**Municipality of Anchorage
Geotechnical Advisory Commission**

**Subject: Geotechnical Peer Review
Proposed Ground Improvements – Armorpack Pier System
FedEx Sorting Facility, Anchorage, Alaska**

SUBJECT: Design Comment Response No. 2 - Geopier Soil Reinforcement
FedEx Sorting Facility – Foundation and Slab Support
Anchorage, Alaska

Plate 1. Schematic details and dimension of Geopier-Armorpack system relative to footings and slabs.

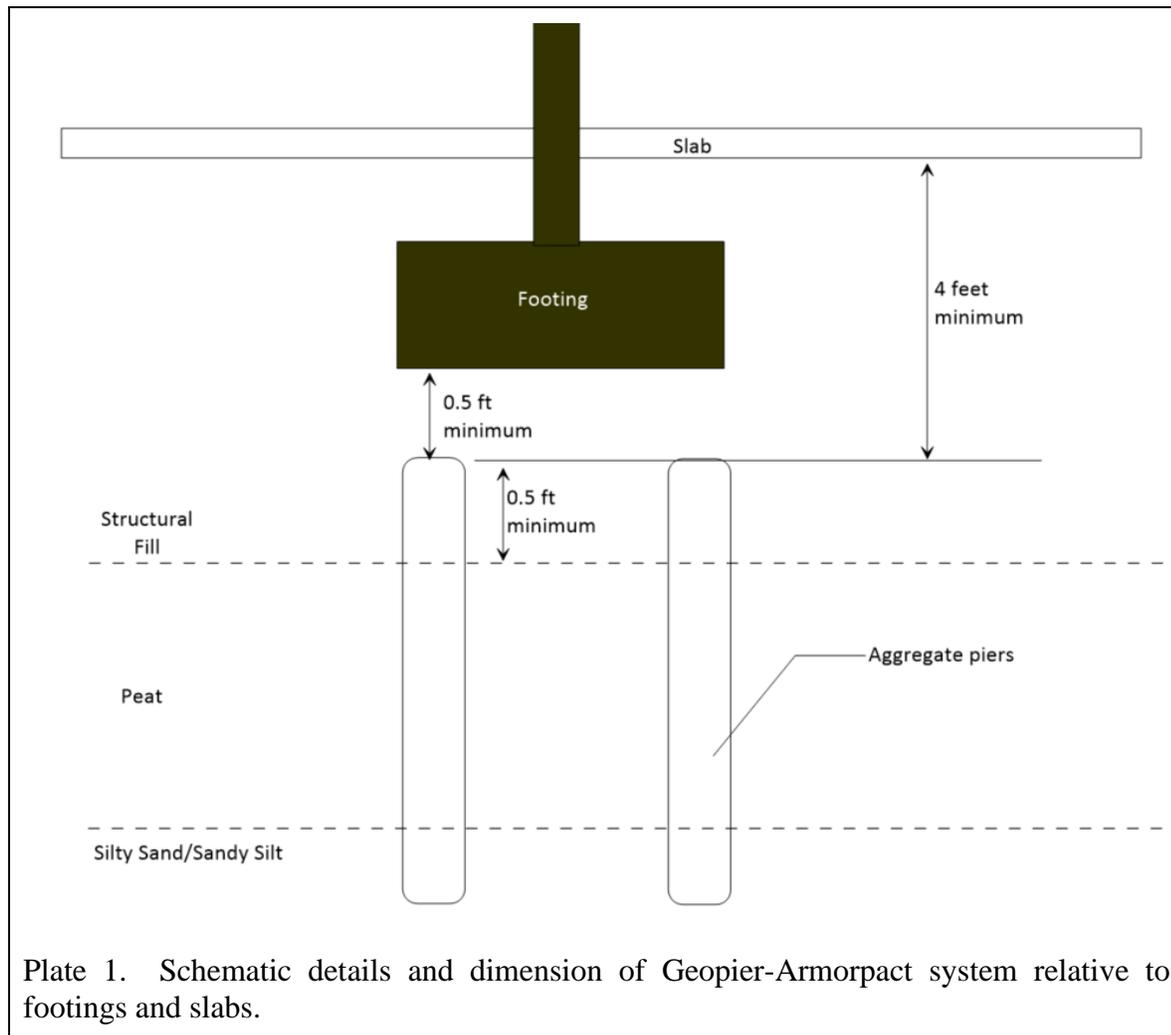
We understand that the City’s reviewer has concerns about the lateral stability of the Armorpack piers when it is subjected to lateral loads. We understand from the structural engineer that the lateral resistance of the building foundation is provided entirely by the passive resistance of the structural fill; friction on the bottom of the footings was ignored in design calculations. We believe this is a conservative but appropriate assumption, based on the limited separation between the bottom of the footings and the fill/peat interface.

Based on the fill depth of about 3½ feet from the bottom of the slab to the bottom of the footing (see Plate 1 on the prior page), the lateral footing movements needed to mobilize the allowable pressure is estimated at 0.42 inches. This is a simplistic but conservative estimate since several factors are not taken into account, including resistance provided by the slab. We regard this as the upper bound estimate.

Since the footings are only 6 inches above the top of the Armorpack piers and one foot above the peat, the top of the Armorpack piers is likely to move laterally as well, potentially as much as the footing (i.e., 0.42 inches).

In summary, based on our analysis, the Armorpack pier should perform adequately when subject to the design lateral loads.

Figure 1 – LPILE Analysis Plots

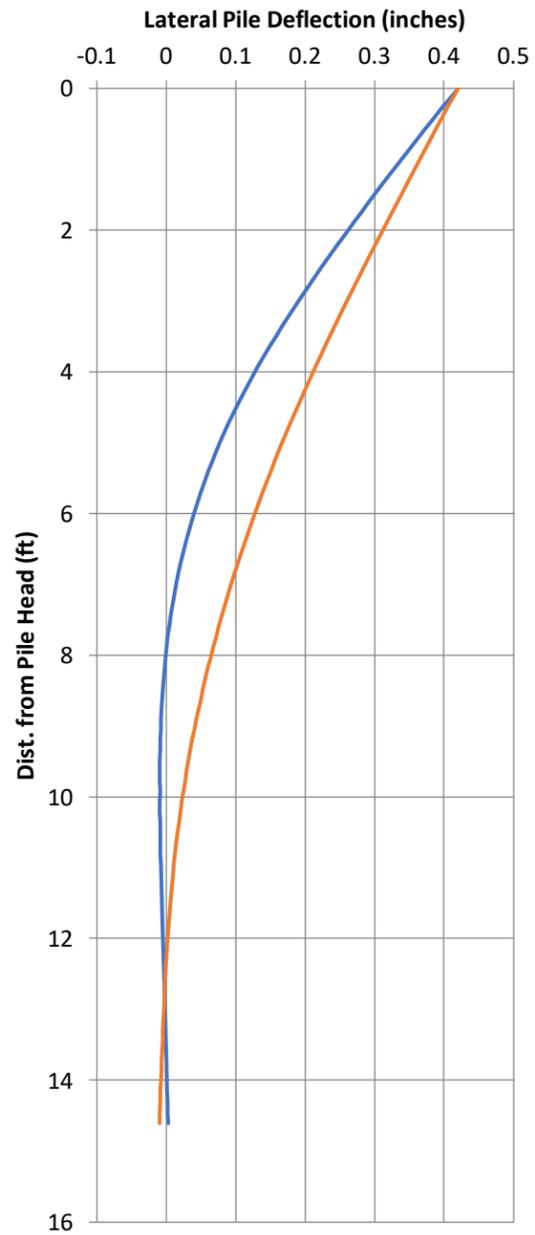
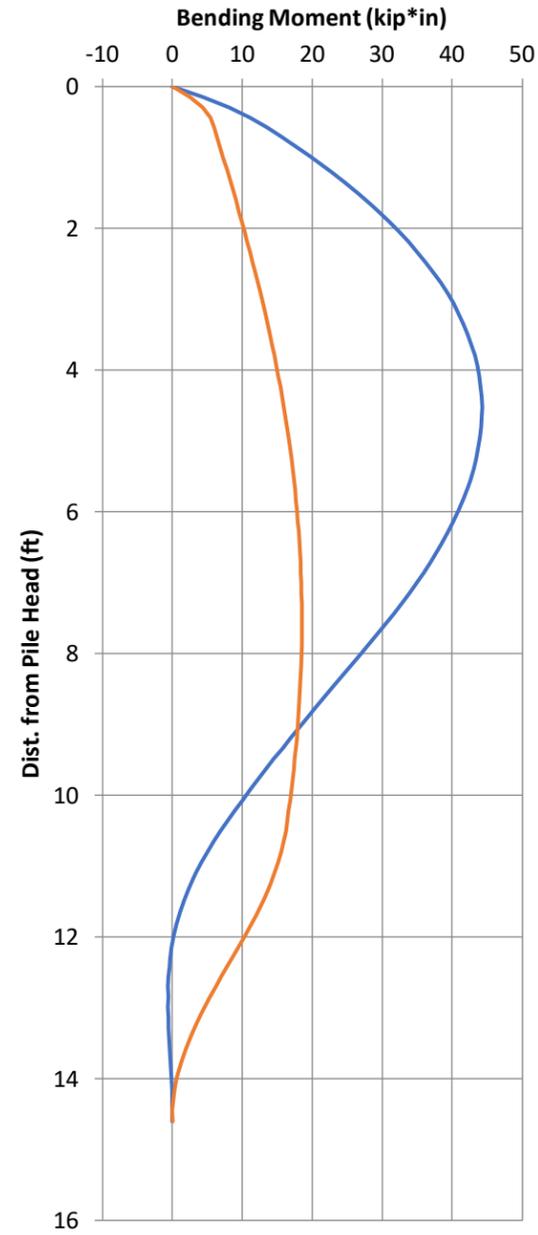
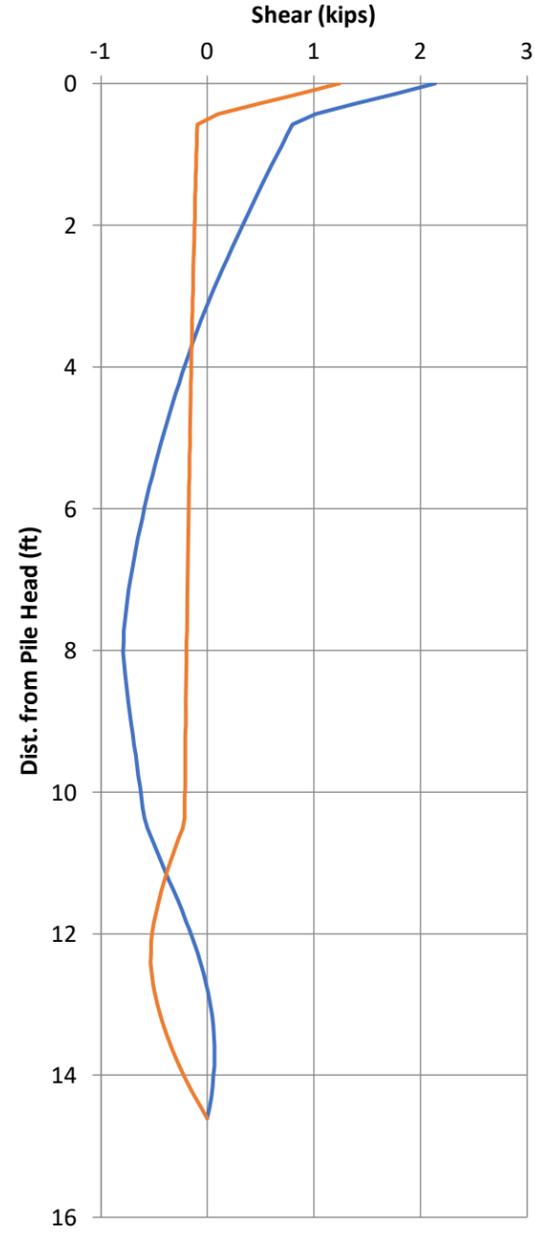
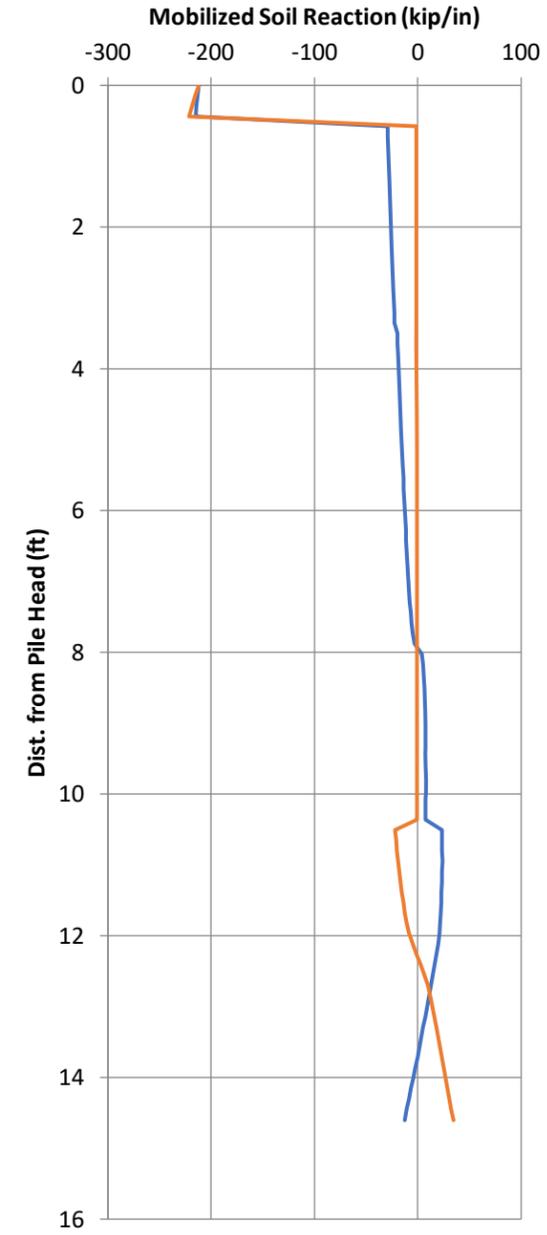
For Case 1, where we utilized the recommended undrained cohesion of 200 psf for the peat, we calculated a maximum bending moment of about 44 kip-in and a maximum shear force of about 2 kips at the top of the piers.

For Case 2, where we utilized a negligible undrained cohesion of 10 psf for the peat, we calculated a maximum bending moment of about 19 kip-in and a maximum shear force of about 1.25 kips at the top of the piers. That is, the stress in the piers is less in lower strength soils when the piers are subjected to the same amount of lateral movement at the top of the piers.

Both cases indicated a relatively fixed base for the portion of the pier embedded in the native sand underlying the peat.

Plots of the computed lateral deflection, bending moments, shear force, and mobilized soil resistance can be seen in Figure 1, attached at the end of this report.
